Docket No. 50-537
HQ:S:82:058

RESPONSES TO REQUEST FOR ADDITIONAL INFORMATION

Reference: Letter, P. S. Check to J. R. Longenecker, "CRBRP Request for Additional Information," dated April 30 and May 14, 1982

Figure QCS760.96-1
PUMP CHARACTERISTICS CURVE

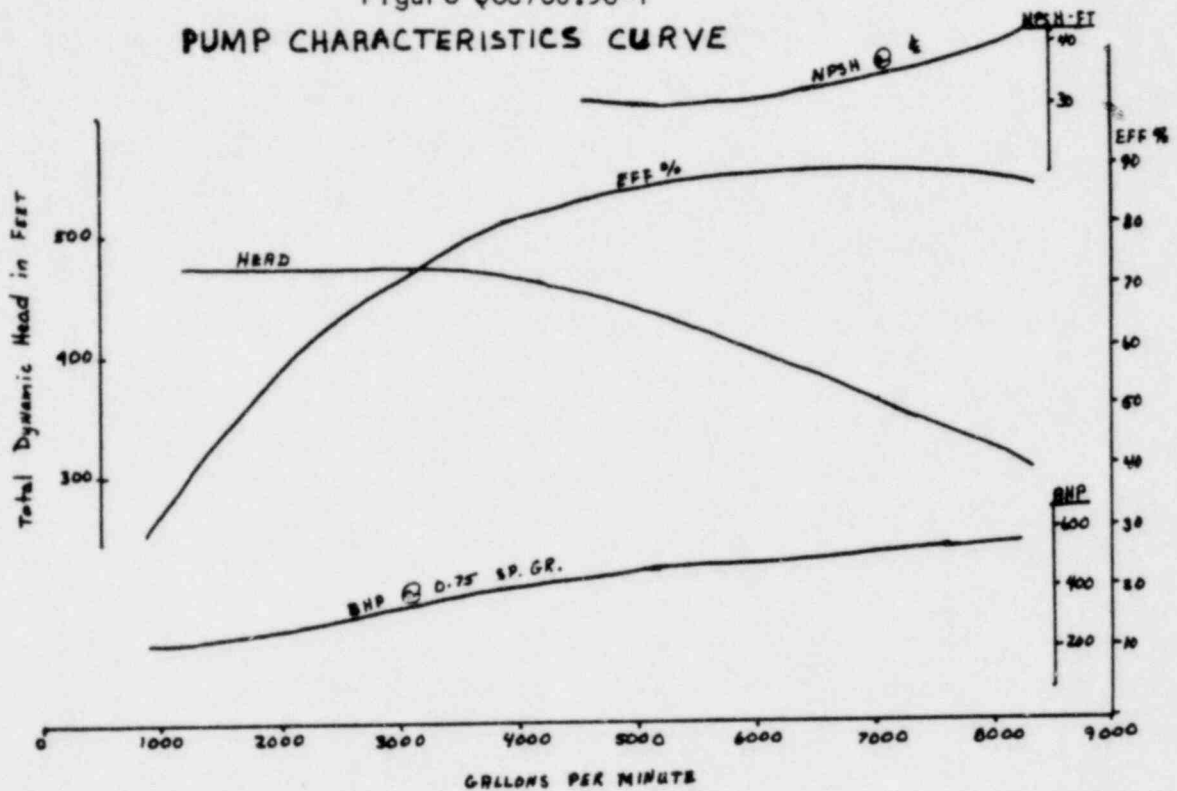
The recirculation pump is described as single speed, yet will experience varying mass flow rates at different power levels and will go through varying speeds while coasting down after a trip. How does the pump head vary with flow rate and speed, i.e., what does the homologous pump curve look like?

The pump curves are attached as Figures QCS760.96-1, 2. The curves were established by actual vendor pump testing. The recirculation pump is a single speed unit with a Design Speed of 1794 rpm, a Design Flow of 5920 GPM, and a Design Dynamic Head of 397 ft. This design point is marked on the attached curve. The pump conditions given in the "Coast Down Curve" are measured on the suction side of the pump.
